Site Plan Review FCC Environmental Services 560 Randolph Ave

**Zoning Committee Public Hearing – April 24, 2025
File #25-015-397**

FCC Environmental Services – 560 Randolph Ave

Existing Conditions

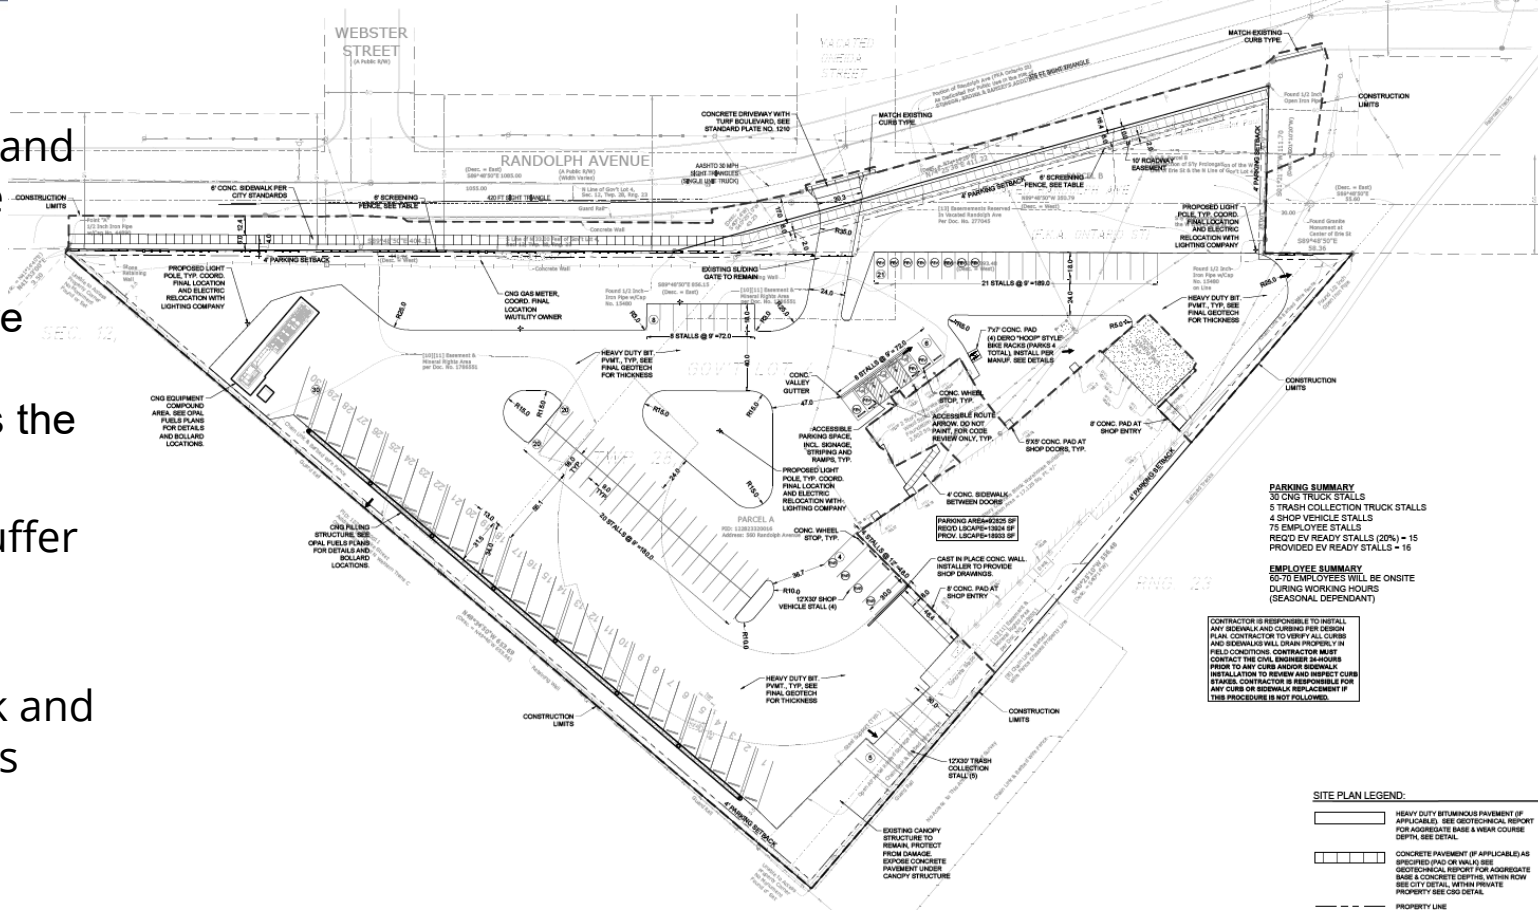
- Admin/office buildings
- Most recent use was a tow truck operator
- Unpaved, gravel lot
- Perimeter chain link and barbed wire fence
- No adjoining public sidewalk or trees

Protection of adjacent and neighboring properties through reasonable provision for such matters as surface water drainage, sound and sight buffers, preservation of views, light and air, and those aspects of design which may have substantial effects on neighboring land uses

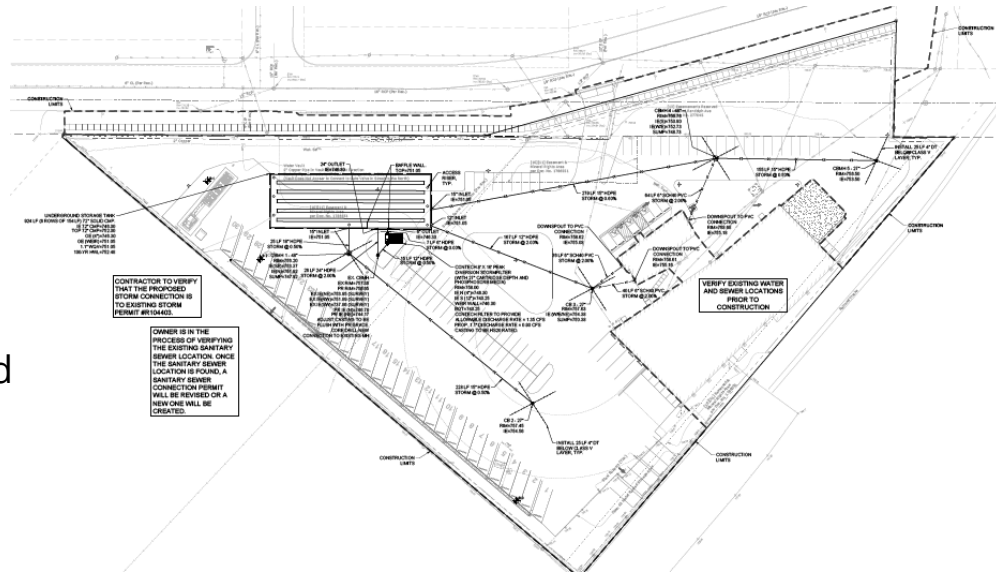
- Stormwater runoff will be improved by best management practices (BMPs)
 - City's stormwater run-off rate control and Watershed stormwater quality requirements
- The CNG station will not store or produce materials or waste that will contaminate surface or ground water
- CNG operations shall be conducted, operated and maintained in accordance with any necessary permits of the state pollution control agency, the county and the city

- Parking setback significantly exceeds the min 4-foot setback requirement, buffering abutting properties from the facility
- Parking and outdoor storage design standards for landscaping, tree planting, screening, and lighting are met

Safety and convenience of vehicular and pedestrian traffic both within the site and in relation to access streets, including traffic circulation features, the locations and design of entrances and exits and parking areas within the site

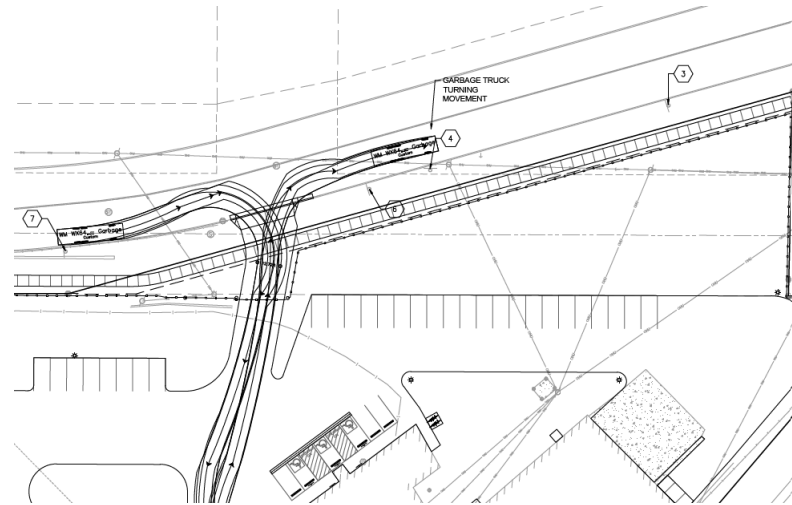
- Transportation Study assessed vehicle trip generation and traffic impact of FCC's operations
- Parking and vehicle storage are located interior to 4-acre property
- Accessed off Randolph Ave, a collector street and Ramsey Co right-of-way
- Existing driveways to be consolidated and right-sized for the fleet vehicles
- Public Works and Ramsey County refined site improvements to enhance pedestrian safety including boulevard expansion and location of new public sidewalk

The satisfactory availability and capacity of storm and sanitary sewers, including solutions to any drainage problems in the area of the development

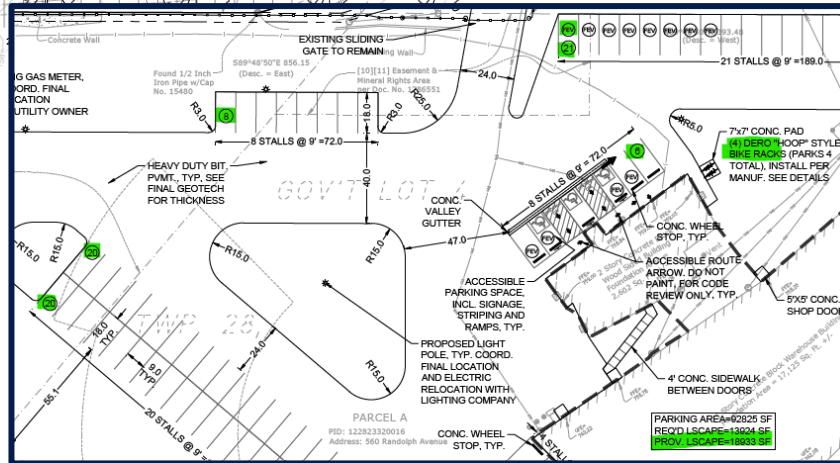
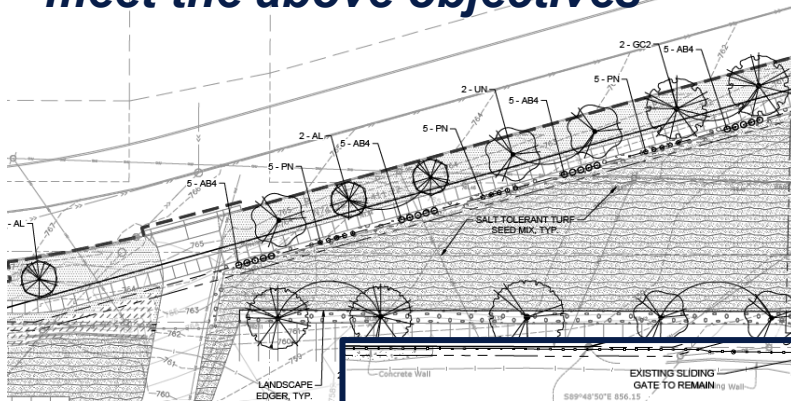
- Availability and capacity of public storm and sanitary sewers are deemed satisfactory
- Stormwater runoff will be improved by best management practices (BMPs) to meet City and Watershed District treatment requirements
- Utility services will be connected to existing public infrastructure under PW Sewers Permits
- Existing septic system to be removed and connection made to public sanitary utility

Sufficient landscaping, fences, walls and parking necessary to meet the above objectives

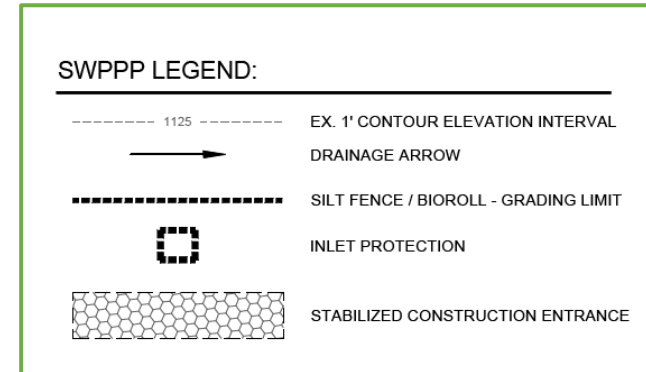
- New boulevard trees will be planted along Randolph Ave
- Decorative, six-foot tall, obscuring fence and landscaping along Randolph Ave property line serves to screen the outdoor storage
- 75 surface off-street parking spaces, includes:
 - 16 electric-vehicle ready spaces
 - 3 ADA spaces
